Model: Z-C2	Date: 08-Jan-14	No.: RD193001
-------------	-----------------	---------------

Subject: Firmware Release Note: Engine		Prepared by: Y. Urushihara	
From: 1st Tech Service Sect., MFP/Printer Tech Service Dept			
Classification:	<input type="checkbox"/> Troubleshooting <input type="checkbox"/> Mechanical <input type="checkbox"/> Paper path <input type="checkbox"/> Product Safety	<input type="checkbox"/> Part information <input type="checkbox"/> Electrical <input type="checkbox"/> Transmit/receive <input checked="" type="checkbox"/> Other (Firmware)	<input type="checkbox"/> Action required <input type="checkbox"/> Service manual revision <input type="checkbox"/> Retrofit information <input checked="" type="checkbox"/> Tier 2

This RTB has been issued to announce the firmware release information for the **Engine**.

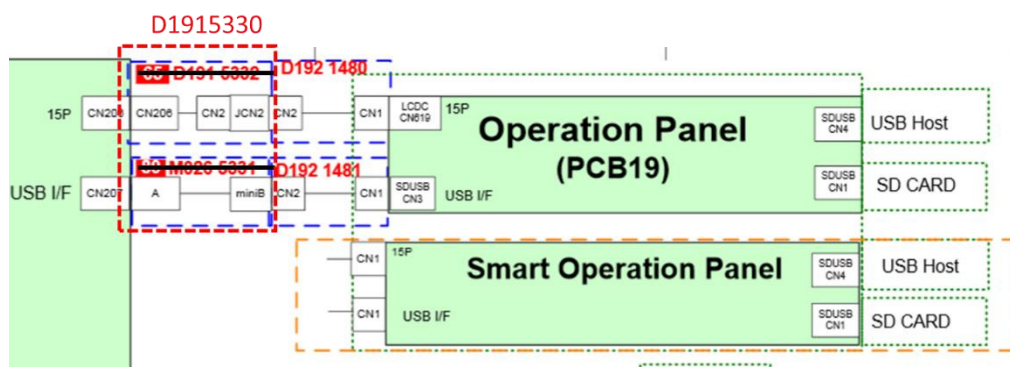
Please correct your Z-C2 Point-to-Point Diagrams as follows.

- P/N D1915332 and M0265331 were deleted, as they are NOT registered as Service parts.
- P/N D1915330 was added, as this part includes the above two parts.

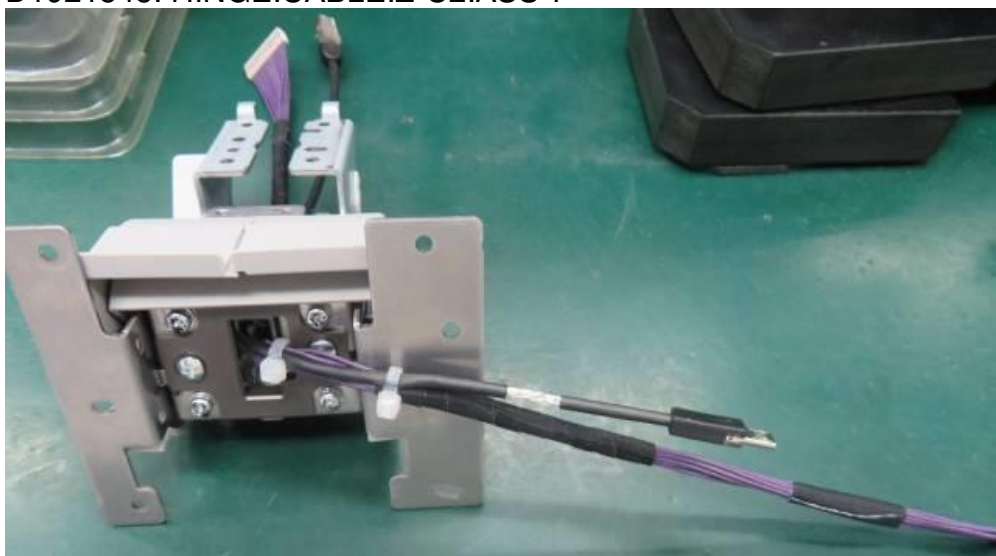
The harness is pinched by the hinge, because it is not bound at the correct location.

Replace the harness with a new one.

As a preventive measure, bind the harness and hinge at the correct location.

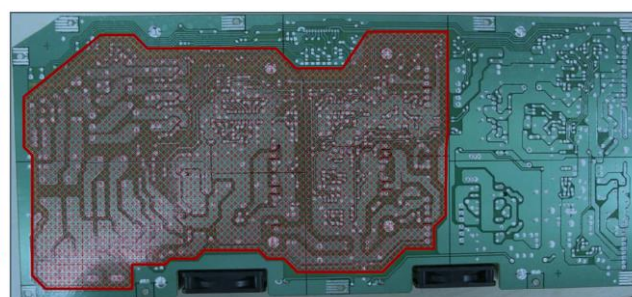
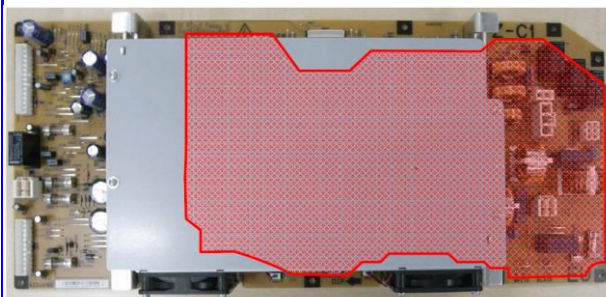
Please add the following caution in the field service manual in this section:  
Replacement and Adjustment > Electrical Components > PSU Box/PSU

No.: RD193055

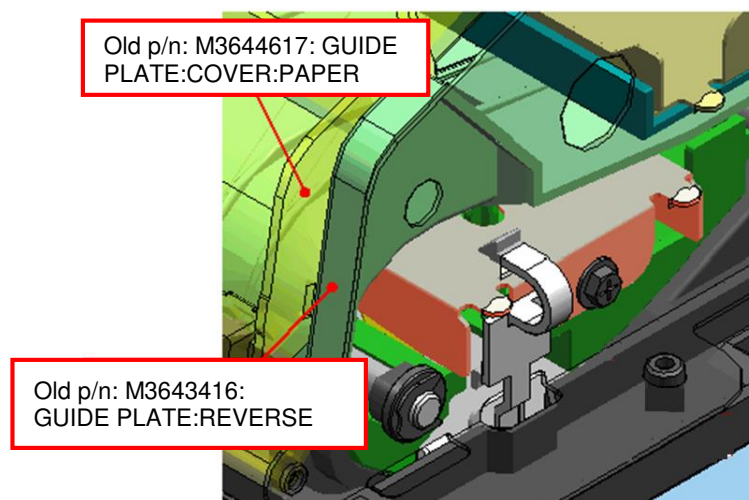
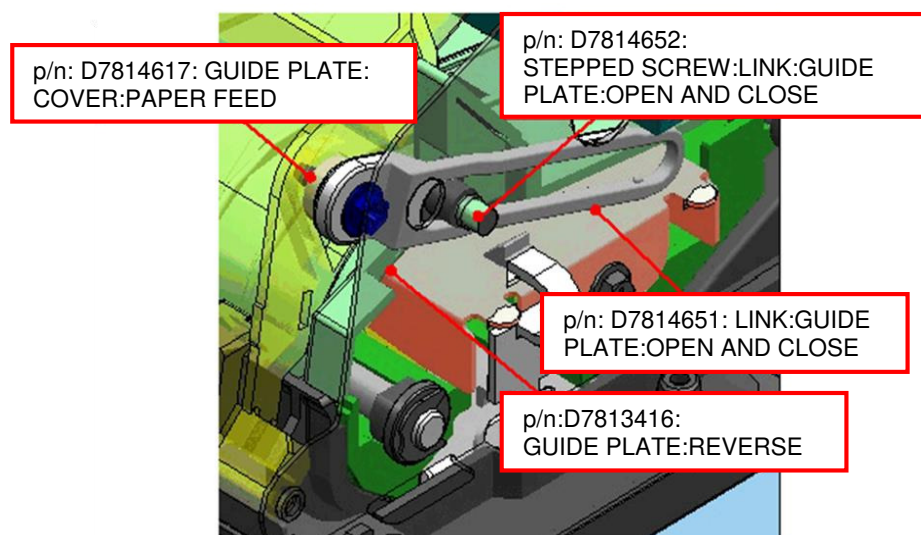
The ARDF left cover comes off, if opened too much.

The hook connecting the guide plate in the ARDF left cover with the ARDF lever bends and comes off.

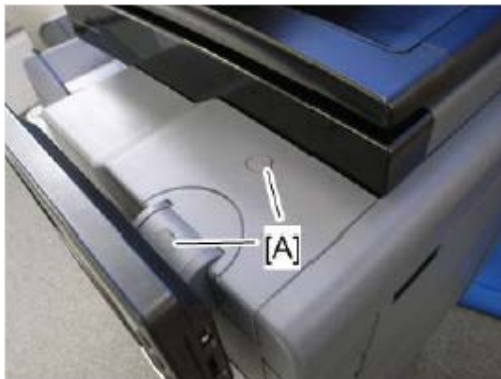
**Reason:** Production of the old motor has ended, and it has been changed to a new motor.

Old	New
	AX040241	D5865311
DC BRUSH MOTOR
